Subject: Duke Energy Carolinas, LLC
Oconee Nuclear Station, Units 1, 2, and 3
Docket Nos. 50-269, -270, and -287
Emergency Plan Revision 2016-003

OCONEE NUCLEAR STATION EMERGENCY PLAN

SUBJECT: Emergency Plan Revision 2016-003

FIGURE B-2
OCONEE NUCLEAR STATION
TECHNICAL SUPPORT CENTER ORGANIZATION CHART

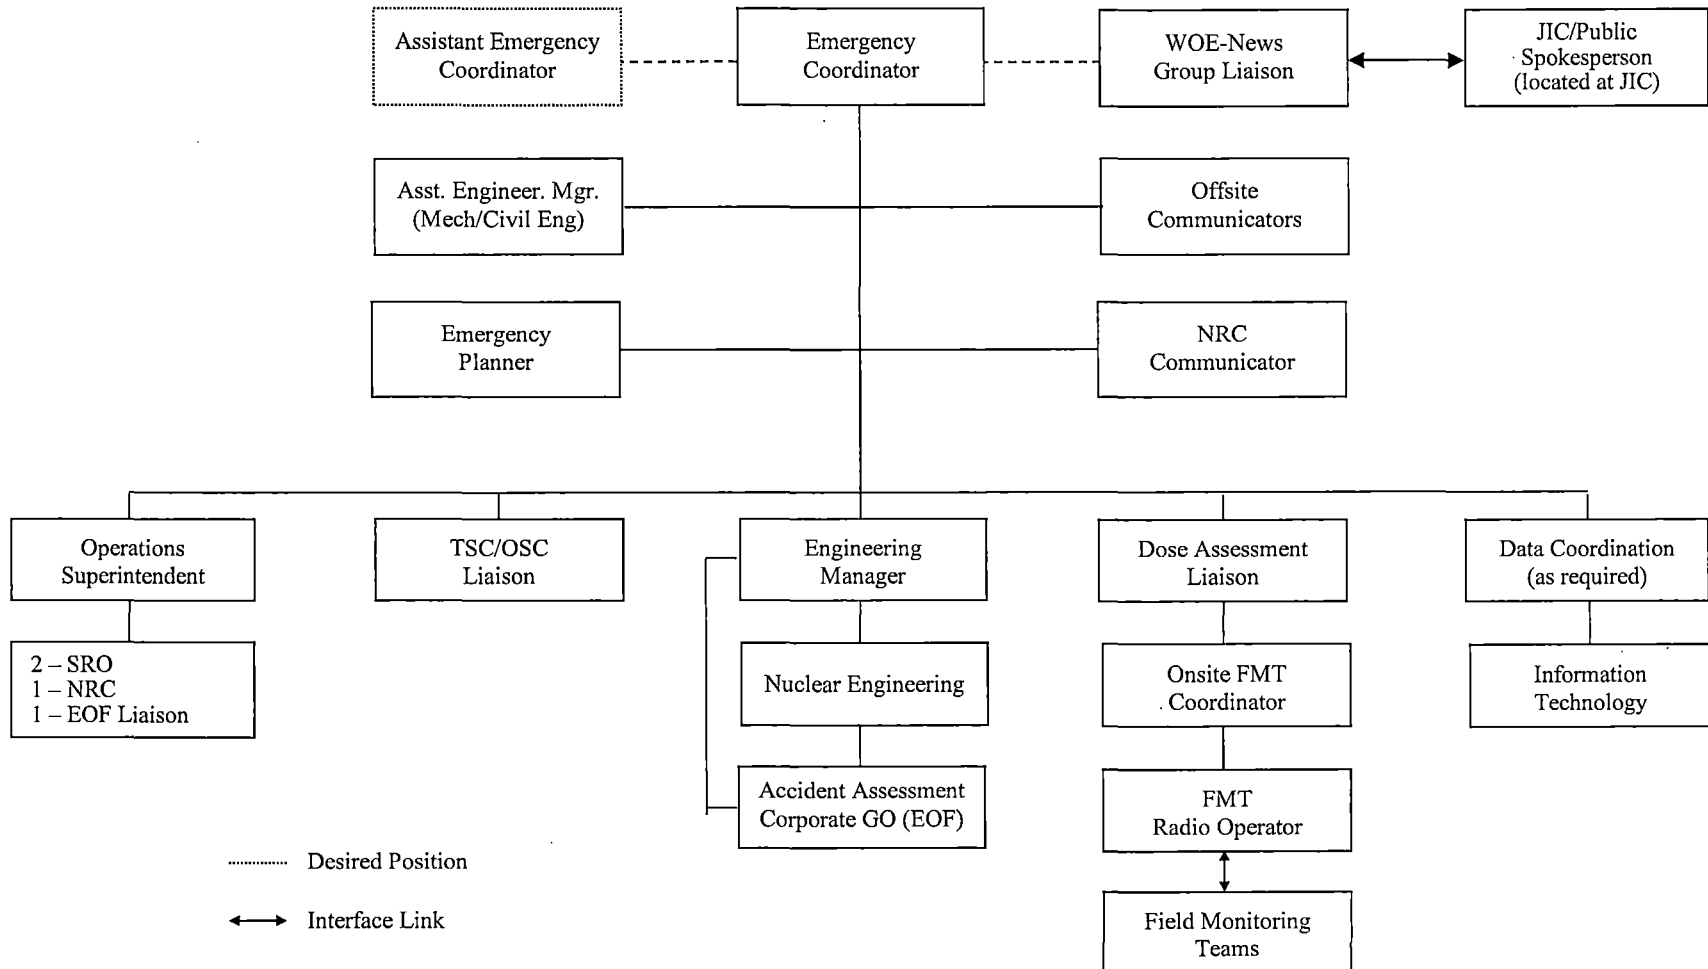
#	Page /Section	Current					Proposed Change		
1.	B-6 B-20	Safety Assurance					Organizational Effectiveness		
2.	Figure B-2	TSC/OSC Liaison Tech Assistant (Mod. Engineering)					Deleted

#	Page /Section	Current	Proposed Change																				
1.	B-6 B-20	Safety Assurance	Organizational Effectiveness																				
2.	Figure B-2	TSC/OSC Liaison Tech Assistant (Mod. Engineering)	Deleted, combined with TSC/OSC Liaison position (PRR 02083339)

Section B, there is no staffing reduction to the minimum staffing described in Figures B-8a/b, changes were made for clarification of roles. The combination of the TSC/OSC and TSC/OSC Tech Assist was due to efficient use of personnel and requested via drill critique feedback, both positions use the same personnel qualification guide.. Section P was a housekeeping change to update procedures that have been revised or superseded by fleet procedure. The changes in this revision do not change methods or ability to staff the Emergency Response Organization with principal response organizations and emergency personnel.
